PLANNING, ZONING, & BUILDING DEPARTMENT
PZ&B Staff Memorandum: Architectural Commission (ARCOM)

SUBJECT: ARC-23-013 (ZON-23-028) 177 CLARKE AVE. (COMBO)

MEETING: APRIL 26, 2023

PROPOSED CUBIC CONTENT DIAGRAM
 SCALE: 3/32"=1'-0"

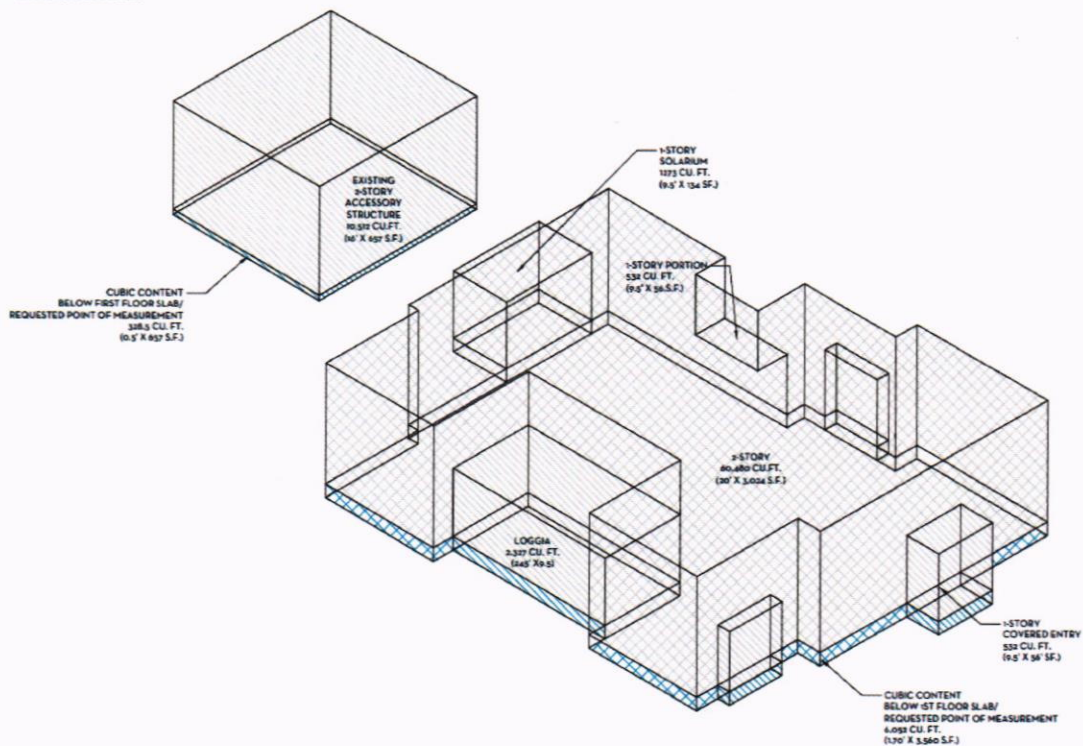
The subject property is a corner lot property zoned R-B. The proposal includes the construction of a new single-family residence with site wide landscape and hardscape improvements, and the retention of an existing nonconforming two-story accessory structure. The applicant is proposing to construct the finished floor of the new building at 9.325' NAVD, lieu of the 7' NAVD required by code. As a note, the finished floor elevation of the existing residence to be demolished is at 10.19' NAVD. All of the zoning calculations relating to the building mass (Height, Overall Height, and CCR) must be taken from the code prescribed point of measurement of 7' NAVD. While the height and overall height conform, even with a finished floor at 9.325' NAVD, a CCR Variance (1) is required, since the lower mass of 2.325' is calculated towards the CCR.

As it pertains to the CCR variance, the house “starts” at a resilient finished floor elevation of 9.325’ NAVD (2’+ of freeboard), but the definition of CCR requires that the calculation of cubic content begin underneath the floor elevation—at the point of measurement, which in this instance is the base flood elevation + one foot of freeboard, or 7’ NAVD. Section 134-2 of the Code defines Cubic content ratio (CCR) “as means a measure of land use intensity, expressing the mathematical relationship between the cubic content of a building and the unit of land”. So in this instance, the base or foundation of the structure, or in other similar cases, actual earth or mound formations on site, count towards the ‘land use intensity’ of the site. The definition continues to dictate “that is arrived at by dividing the gross cubic content, as calculated by multiplying building height as stated in the definition of the term “building, height of (applicable only in the R-B district)”. This nonsensical standard is most clearly illustrated below as portions of non-house are counted towards the calculation.
